Service Bulletin

Subject: New Design Cylinder Heads

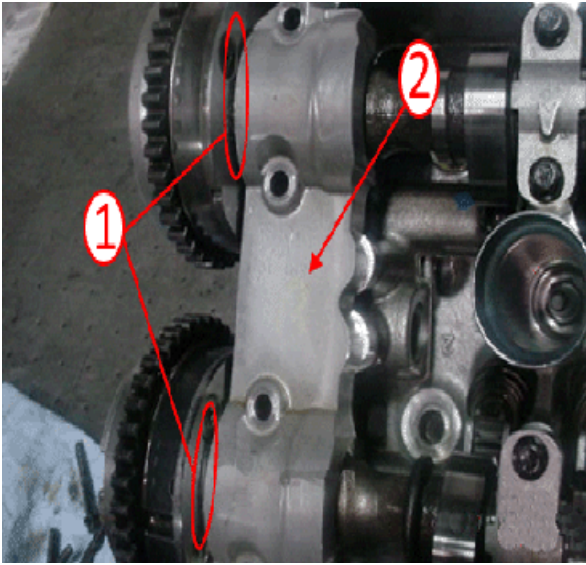
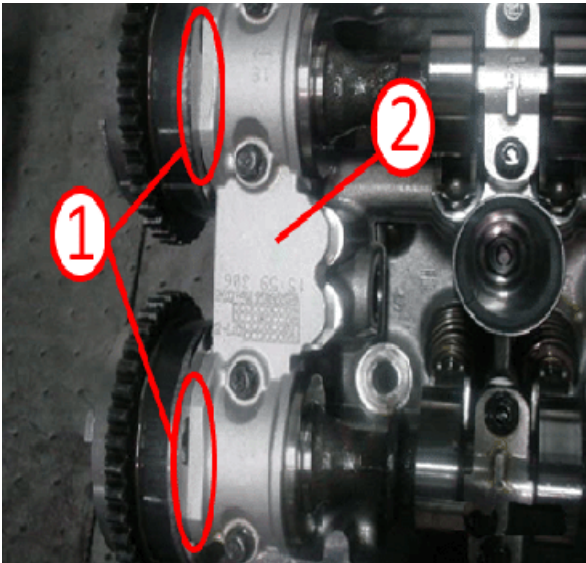
Previously Designed Cylinder Heads used a thrust washer (1) between the actuators and cylinder heads.

The new cylinder heads have a saddle cap (2), which incorporated a thrust surface on the saddle cap, has been designed to reduce the tolerance between the camshaft actuator and cylinder head, eliminating the need for a thrust washer.

Caution: If you are using a 2011 new style "saddle cap" cylinderhead, thrust washers are **not** to be used. The use of thrust washers on the new designed cylinder heads can cause damage to the cam shaft actuator, saddle cap and cylinder head.
